Detailed Site Plan 9113 Baltimore Avenue

DSP-22015

STAFF REPORT

SUBJECT: Detailed Site Plan DSP-22015
9113 Baltimore Avenue

Figure 6: Wall sign located on the northwest corner of building

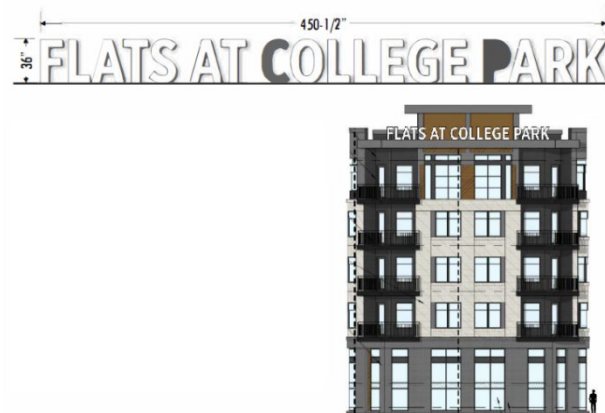
The applicant proposes multiple building-mounted signs: one back-lit, channel-letter, building-mounted marquee sign will be located on a projecting metal canopy at the northwest corner of the building, facing the intersection of US 1 and Delaware Street, as shown in Figure 6. Another vertical, back-lit, sign will be mounted on the western building façade that will be visible from US 1, as shown in Figure 7. Other building-mounted, back-lit, channel-letter signs are proposed along US 1 and Cherokee Street, above the residential, commercial, and parking garage entrances. No sign is proposed for a residential entrance located off Delaware Street. In addition, no sign is proposed at the southwest corner of the building, to identify it for travelers coming up US 1. Additional signs should be provided at both of these locations. The submitted sign details for the project includes the square footage for each sign, but not all the details required to fully evaluate conformance with the sign requirements of the D-D-O Zone (page 254 of the sector plan). The maximum gross area of signs, on a given façade, shall not exceed 10 percent of the façade area of the commercial portion of the building, though architectural signs or signage painted on a building façade or mounted on the roof may exceed this limit, in certain cases. A condition has been included requiring the applicant to demonstrate conformance with the applicable sign requirements.

Figure 9: Building Form exhibit from the Sector Plan

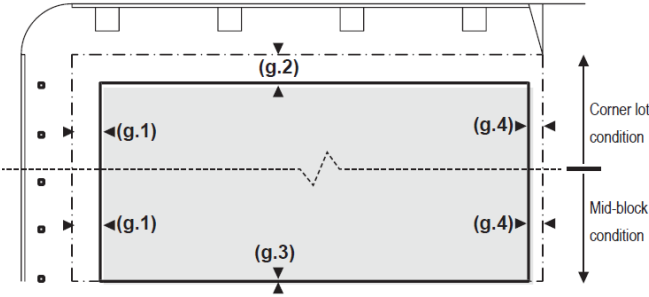
- b. **Building Form/Setback (page 234):** In the Walkable Node Character Area, the front build-to line shall be a maximum of 12 feet for secondary roadways, such as Delaware Street and Cherokee Street.

Along Delaware Street, the building is set back between 11.5 feet and 15.6 feet from the right-of-way line. Along Cherokee Street, the building is set back between 11.9 feet and 29.6 feet from the right-of-way line. The applicant is requesting an amendment of 3.6 feet for the build-to line requirement along Delaware Street and 17.6 feet to the setback requirement along Cherokee Street.

As a result, in this instance, the requested amendment will benefit the development and the development district and will not substantially impair implementation of the sector plan. Therefore, staff recommend **approval** of this amendment.

FIGURE 13
 2025 TOTAL PEAK HOUR
 TRAFFIC VOLUMES

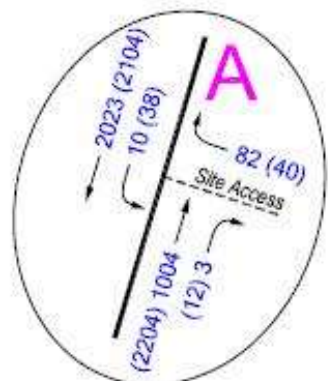
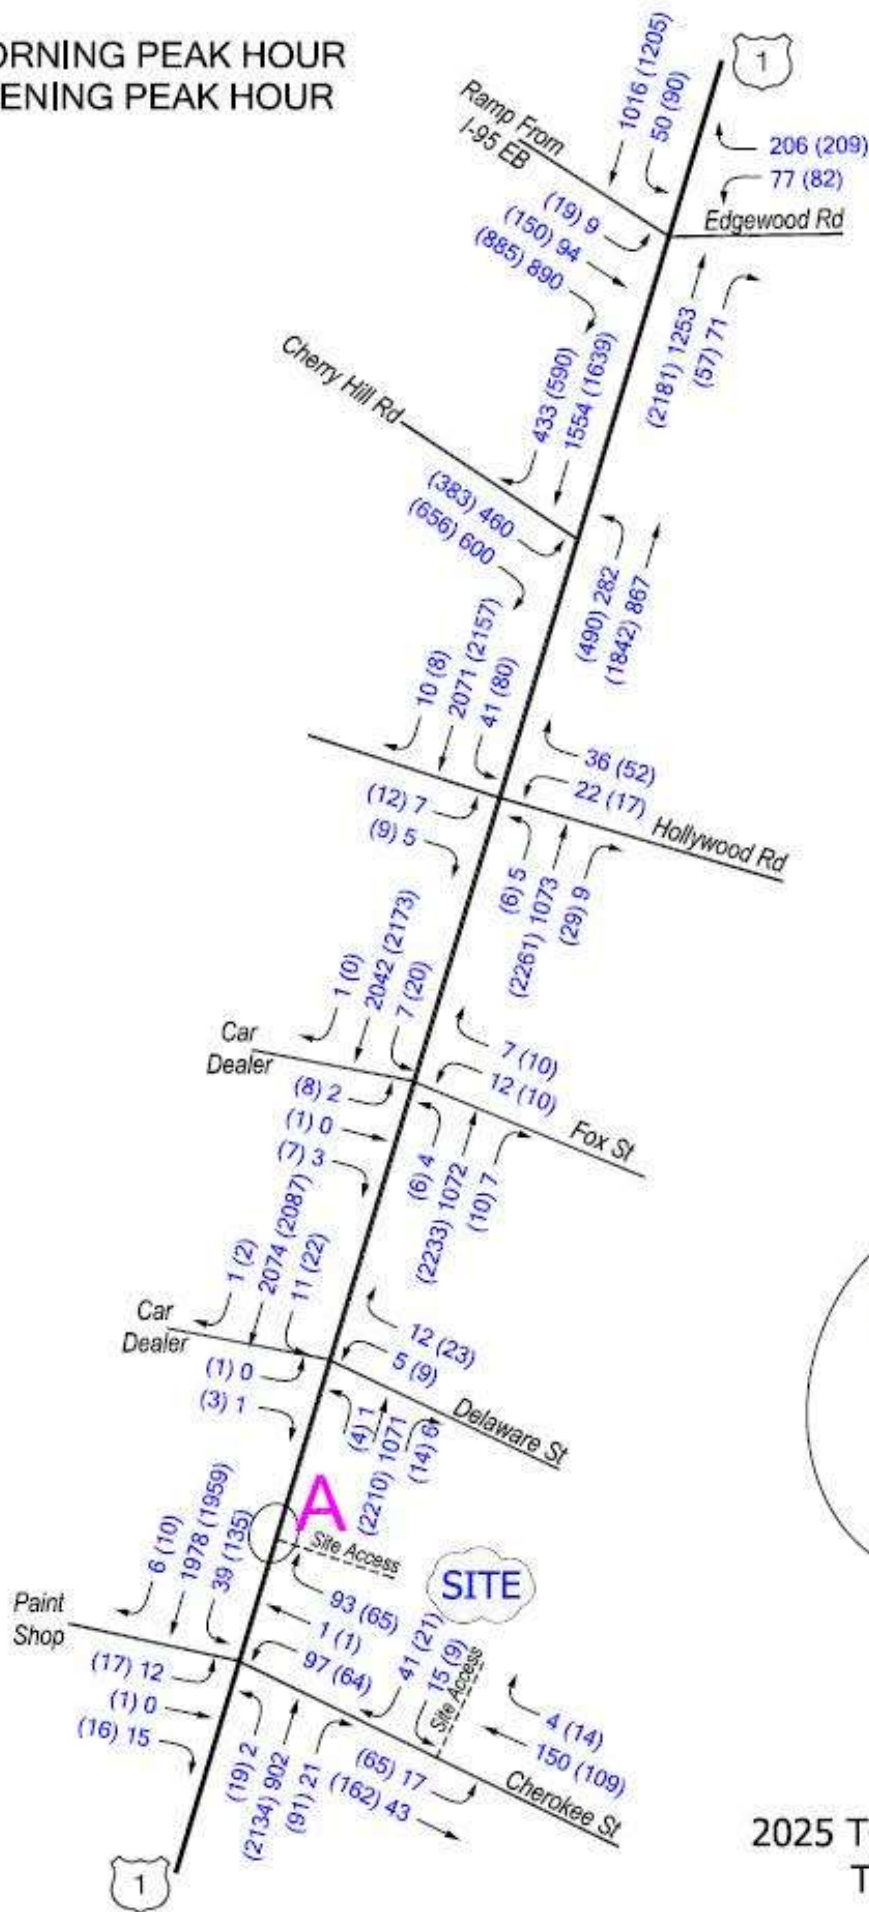
- A copy of Figure 13 (Page 26) of a Traffic Study dated April 6, 2022 showing the estimate 2025 total peak hour traffic volumes for the site. The total volume of trips utilizing the right in access to the parking garage originally proposed by the Applicant was 3 AM and 12 PM peak hour trips;
